ITEM FOR ENVIRONMENTAL COMMISSION AGENDA

NAME & NUMBER OF PROJECT: Persimmons Construction Plans
C8-2019-0080.1B.SH

REQUEST: To cut more than four feet in depth within 100 feet of a classified waterway

STAFF RECOMMENDATION: Staff does not recommend

CUT & FILL EXHIBIT

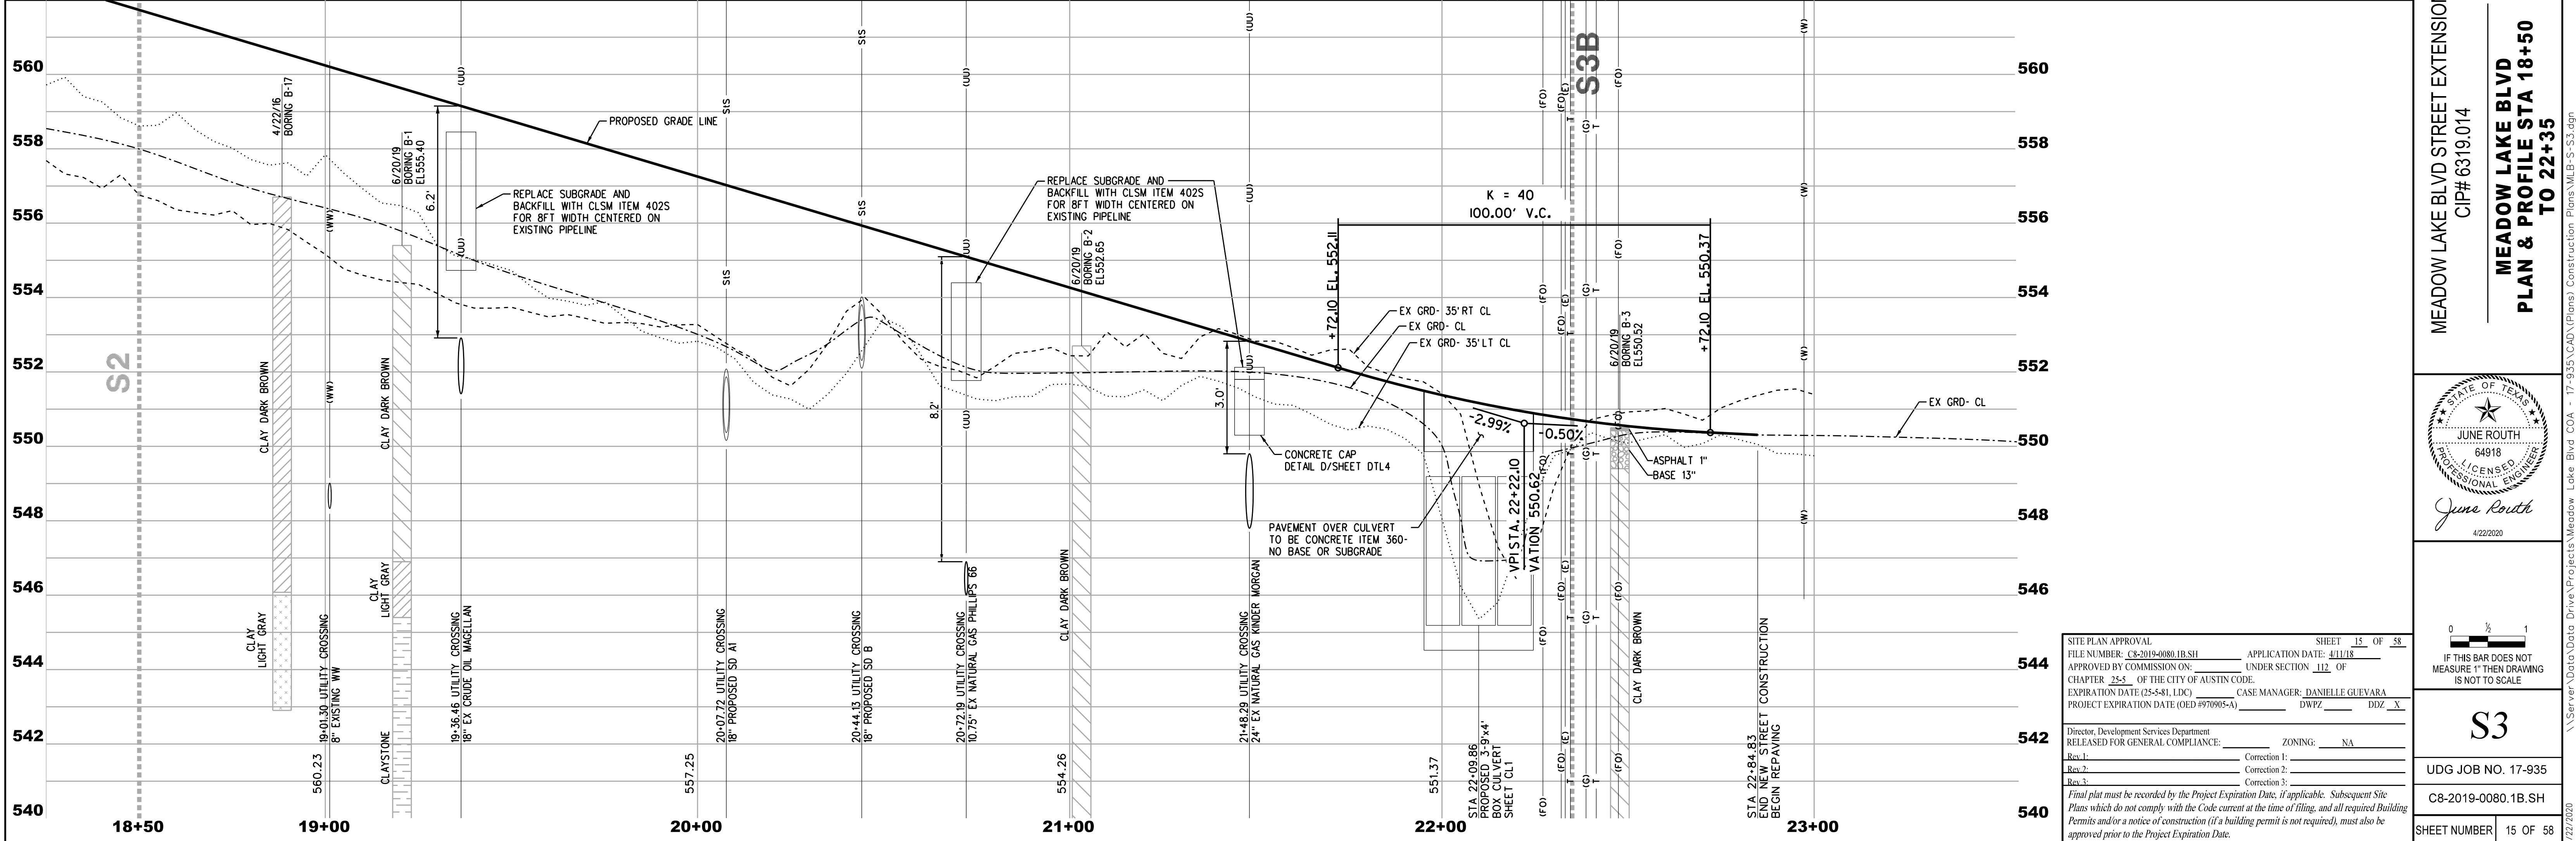
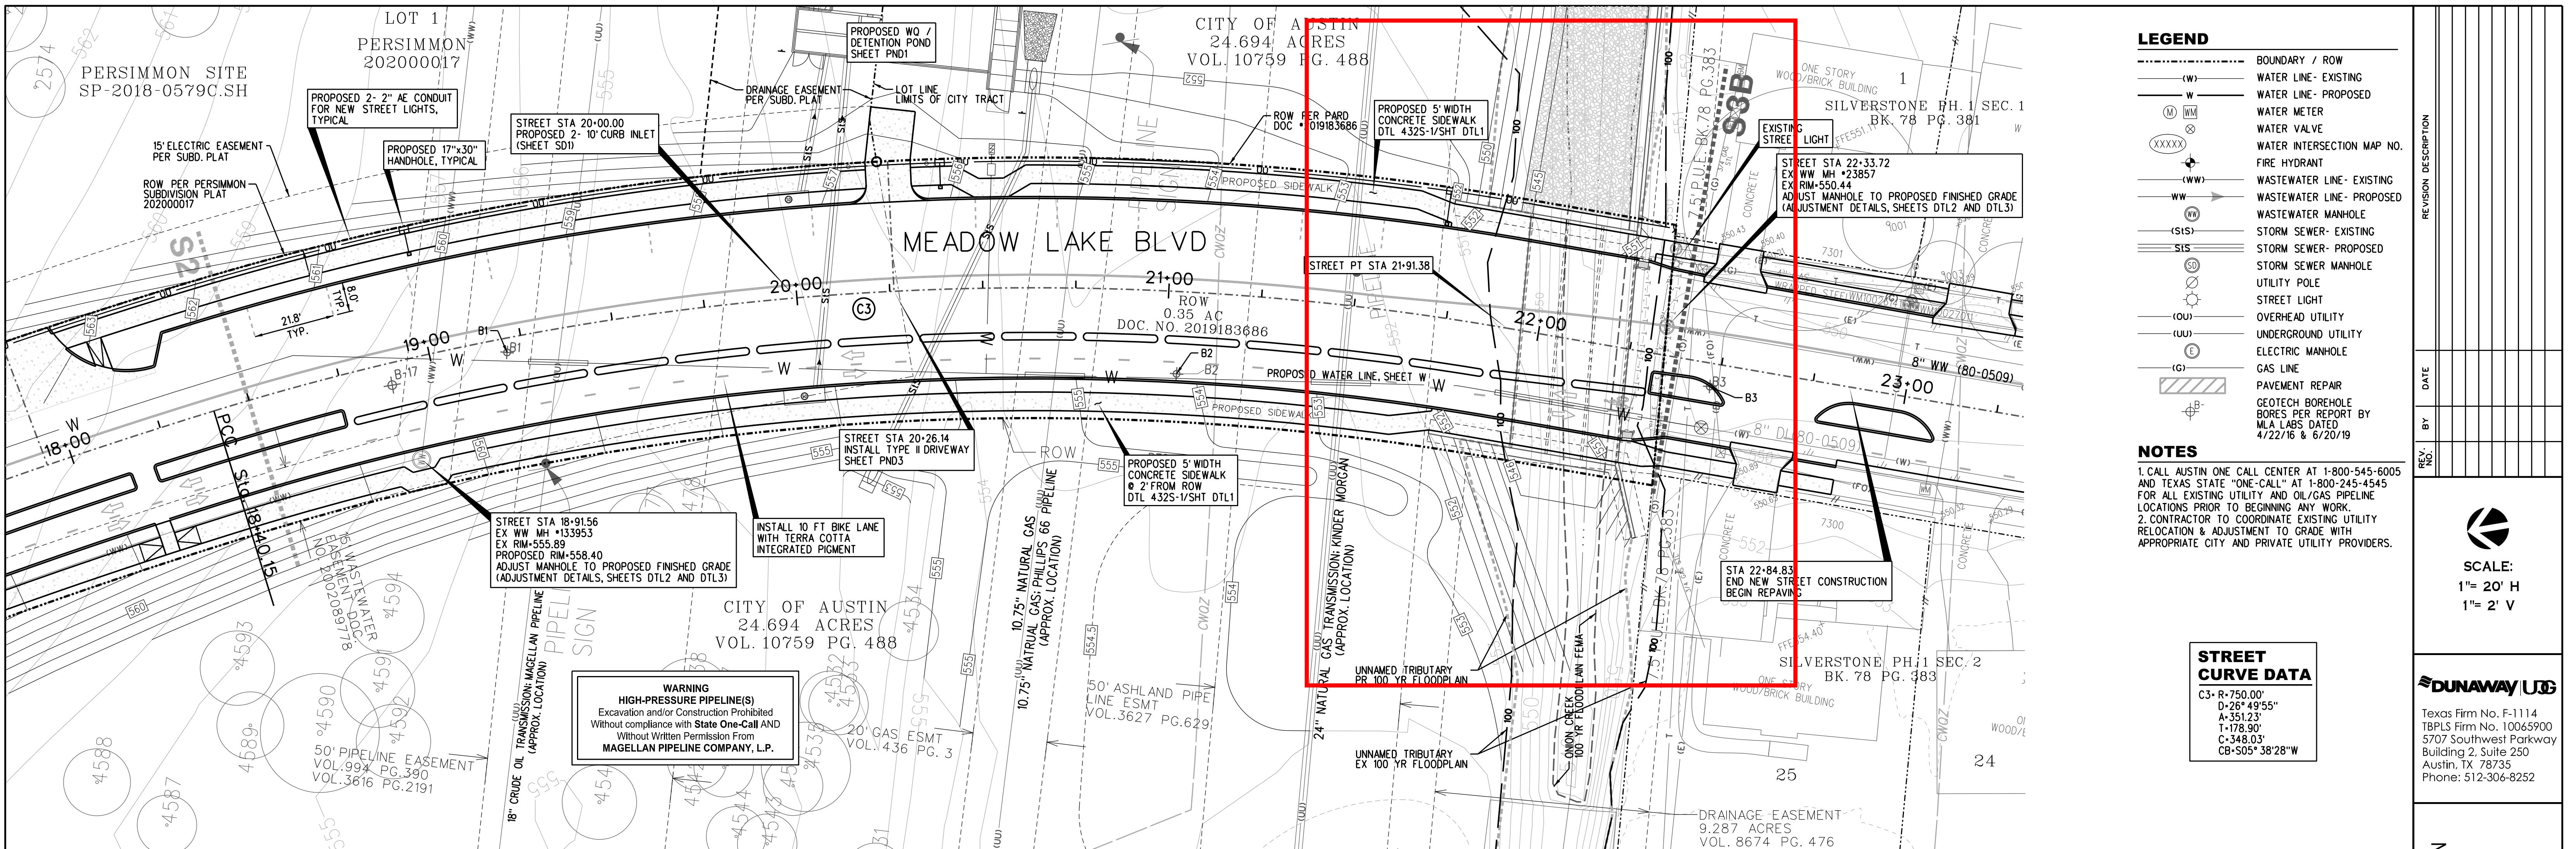
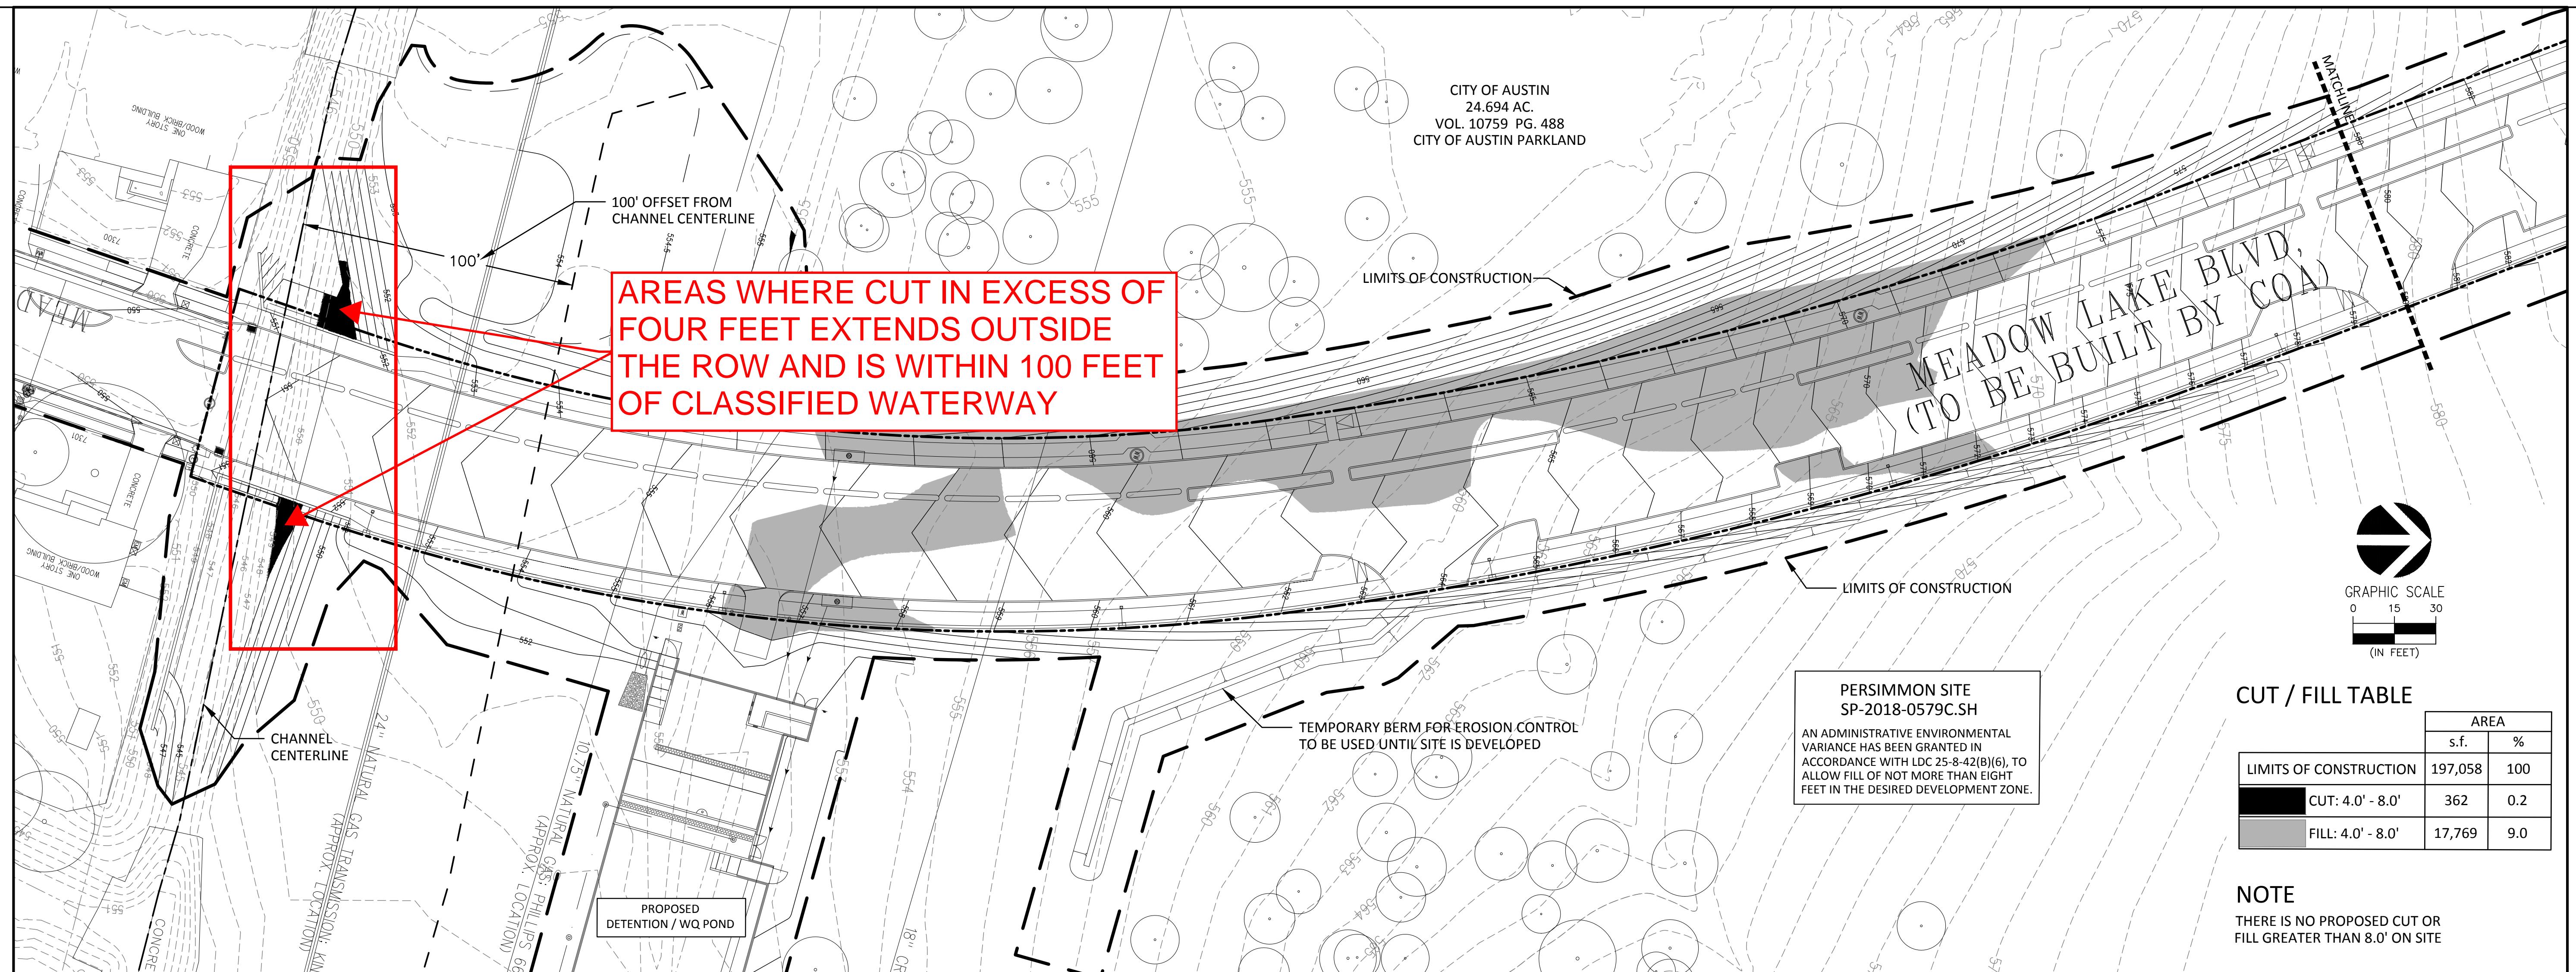
Clearly indicate in what way the proposed project does not comply with current Code (include maps and exhibits)	The 362 sq ft area of cut in excess of 4 ft is necessary for installation of drainage culverts for the Meadow Lake Blvd Road extension project. A cut and fill exhibit is attached.
---	---

- b) Is the minimum deviation from the code requirement necessary to allow a reasonable use of the property;
- Yes / No The proposed grading results in a small area exceeding the cut limit and in a minimum departure from the code requirement.
- c) Does not create a significant probability of harmful environmental consequences.
- Yes / No The cut area is located at the channel transition for the culvert and would not result in additional site disturbance. Revegetation would be provided for all disturbed areas.
3. Development with the variance will result in water quality that is at least equal to the water quality achievable without the variance.
- Yes / No The minimal additional cut will facilitate the culvert without affecting water quality.
- B. Not Applicable
